August 23, 2018

**Re: SPLP Response to Comments  
Hydrogeological Reevaluation Report  
Gradyville Road Crossing HDD (S3-0580)  
DEP Permit Nos. E23-524  
Edgemont Township; Delaware County, Pennsylvania**

**ATTACHMENT 2  
HORIZONTAL DIRECTIONAL DRILL PLAN AND PROFILES**

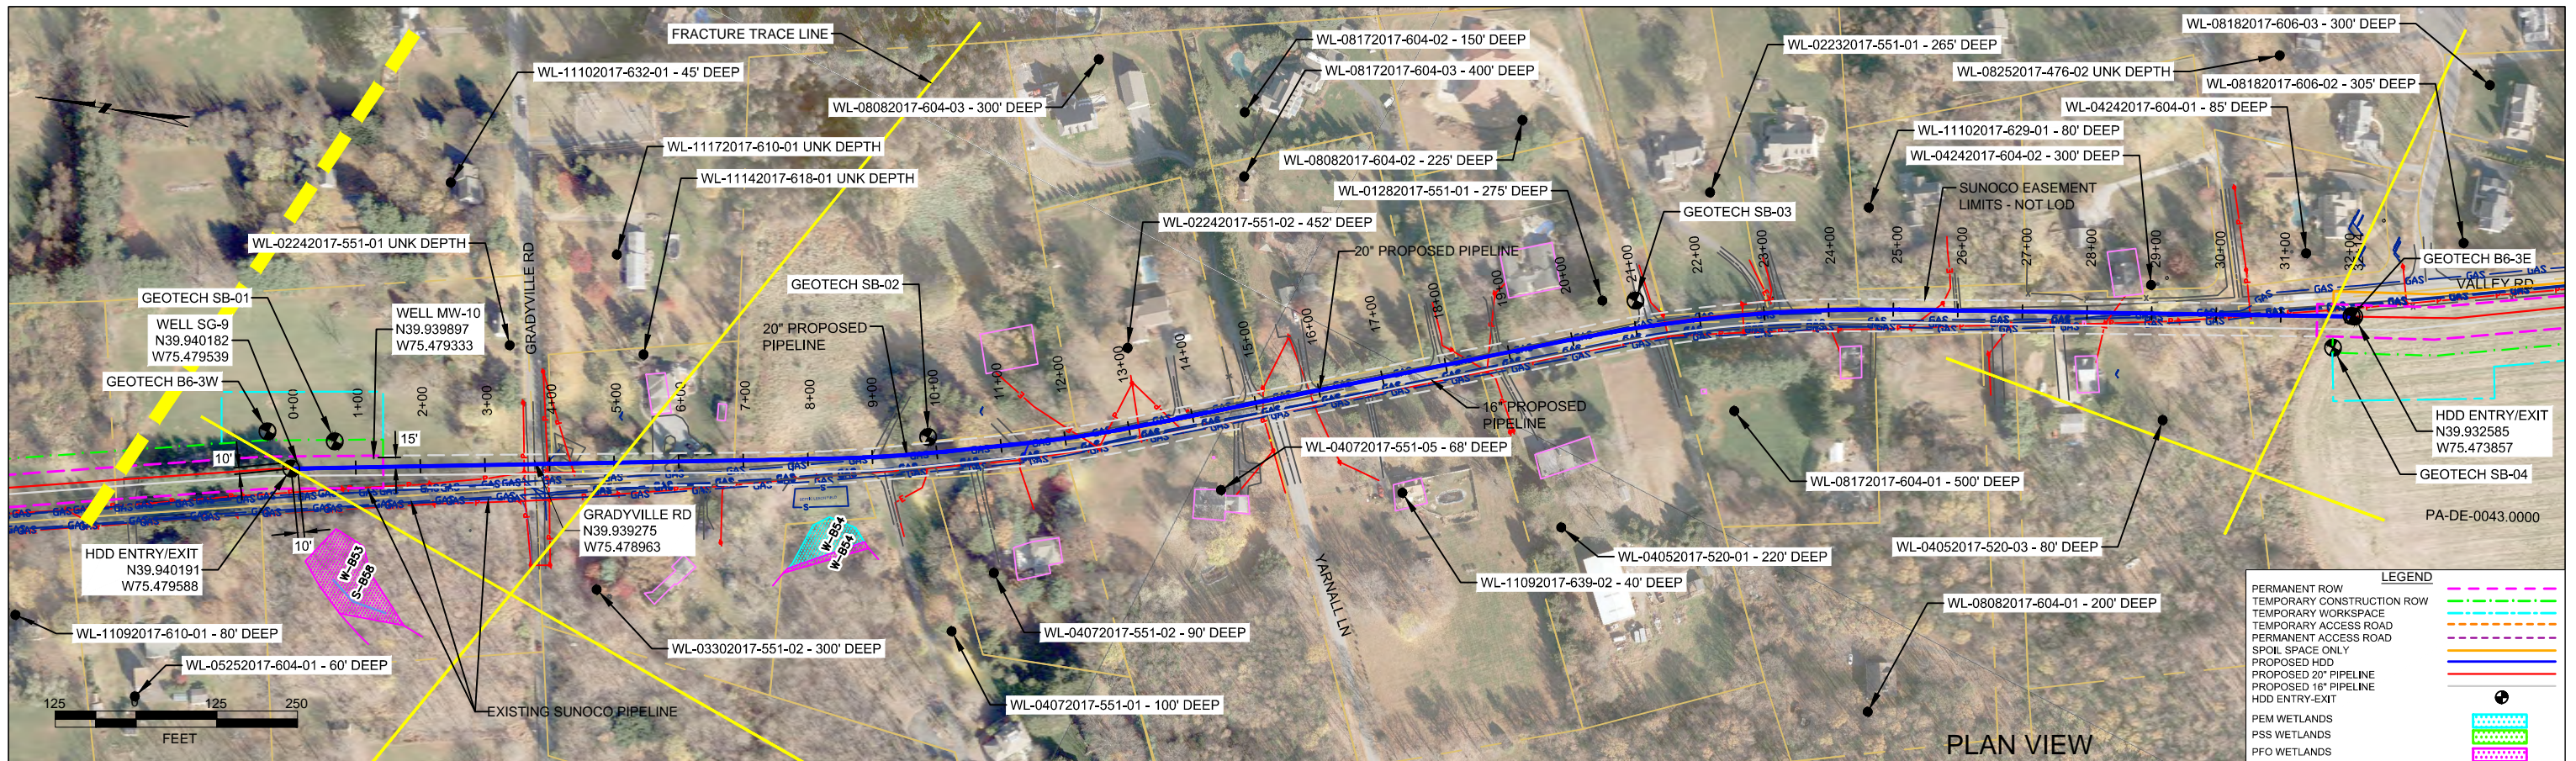
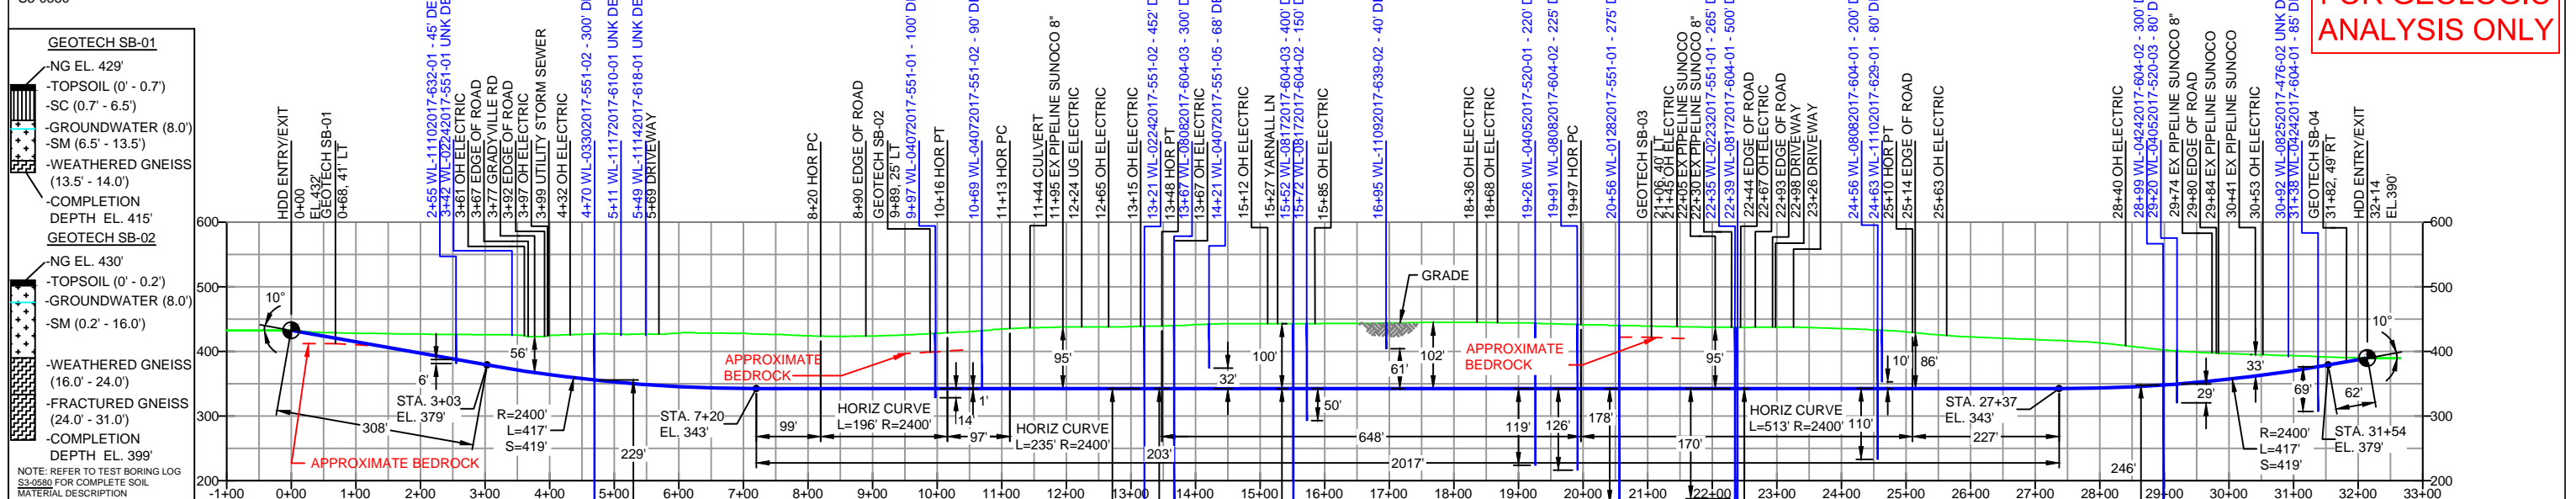
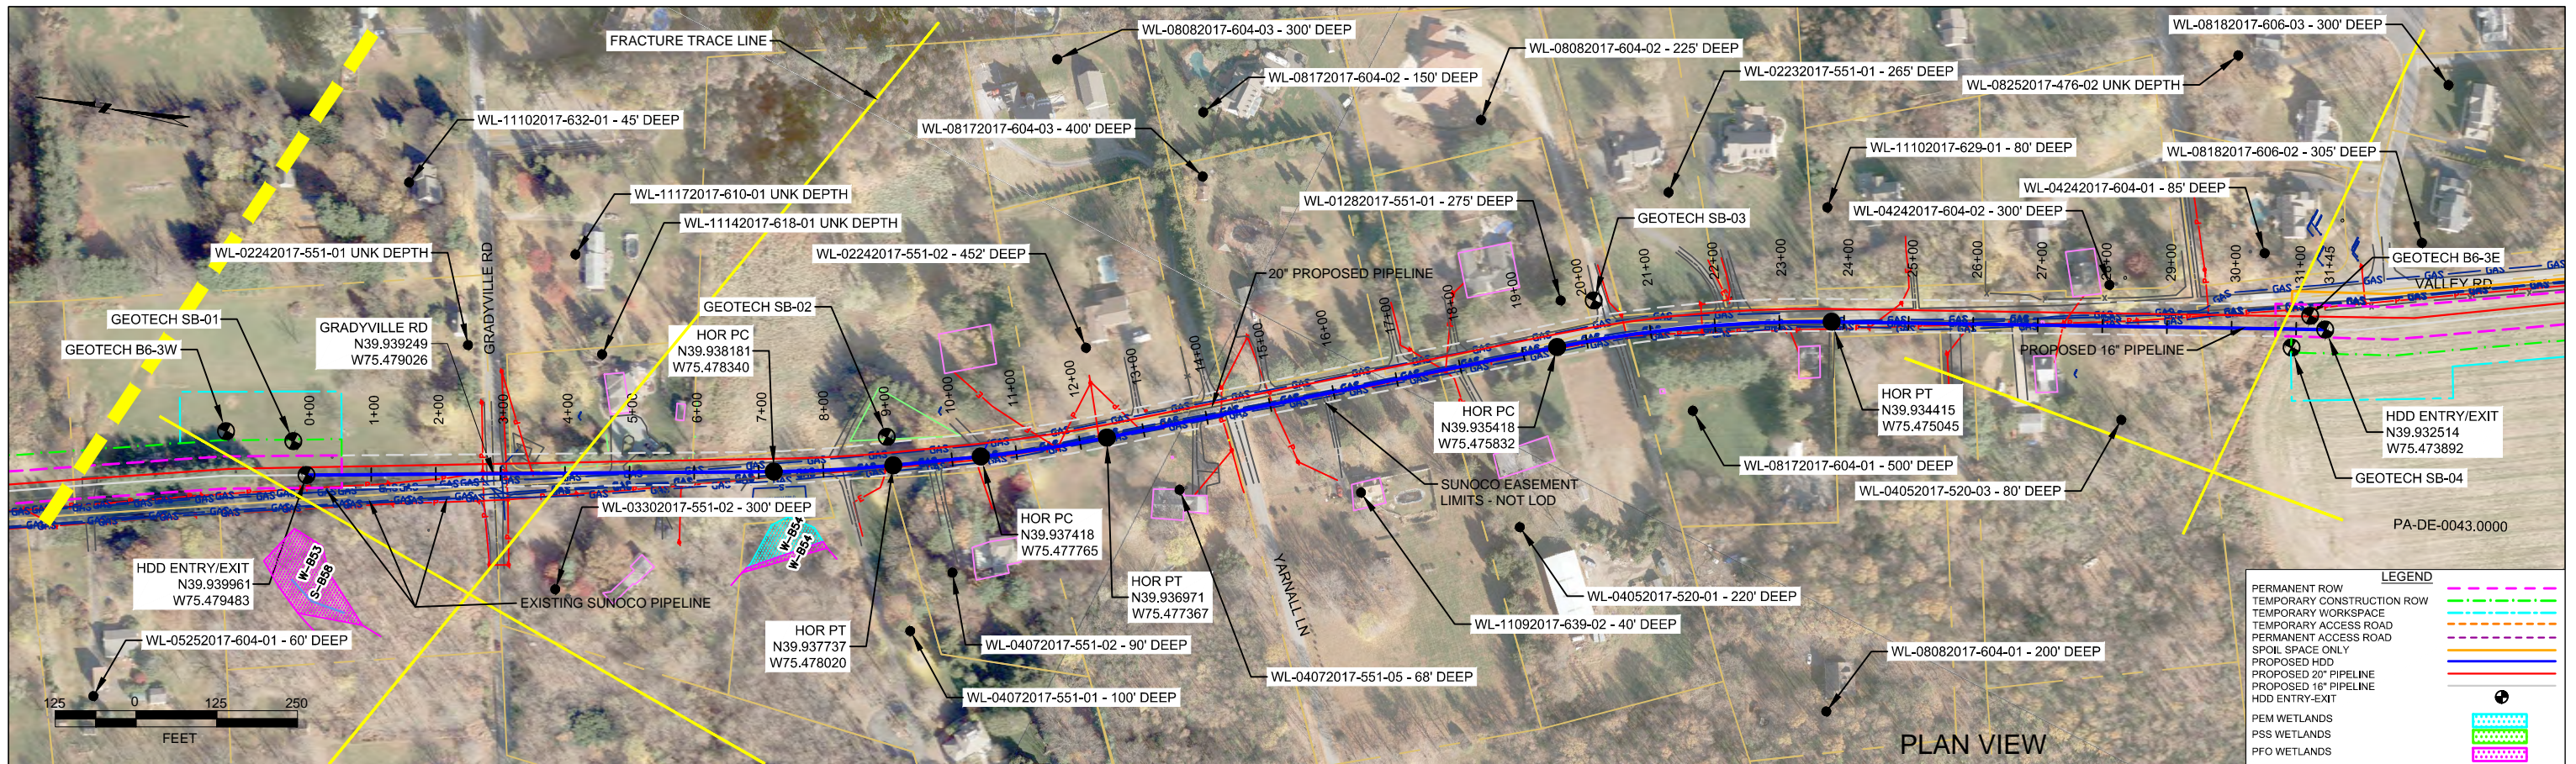
- a. The location on the plan/profile drawings of the repaired leak on the Point Breeze to Montello pipeline as well as the type and location of facilities associated with monitoring and remediation of the spill. This will be useful in predicting when potentially contaminated cuttings and/or contaminated groundwater may be encountered in the HDD.**

**3. The top line of Design and Construction Note No.9 on the plan/profile drawings appears to have been erroneously removed. Provide a correction.**

A representation of the spill and remediation area has been added to a HDD plan and profile and is included in the amended Hydrogeologic Report.

SPLP reviewed the submitted plan and profiles, and checked the same information published on the Departments web page for this reevaluation and did not identify any missing notes. Note No. 9 reads as follows:

*9. PIPE / AMBIENT TEMPERATURE MUST BE NO LESS THAN 30°F DURING PULLBACK WITHOUT PRIOR WRITTEN APPROVAL FROM THE ENGINEER*

This a simple active condition note to the construction contractor. It reflects on the behavior of metal in the pipeline at low temperatures, and nothing more.
